PIT5759H Service Safety Restraints System With DTC B14DC SYM 1B and/or 13

Product Investigation Review Required

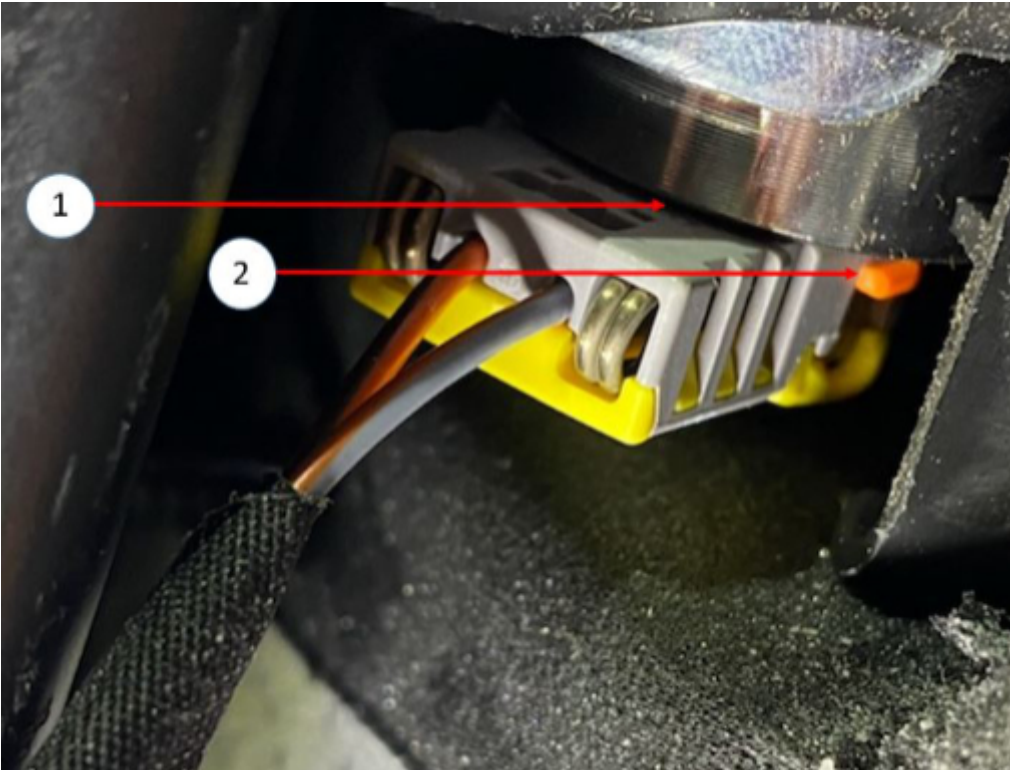
- To disconnect the F106DA Driver's front seat inboard air bag connector the air bag will need to be removed from the seat, follow SI service procedure.

Note: Hold both sides of the zipper straight while unzipping the seat cover or zipper damage will occur.
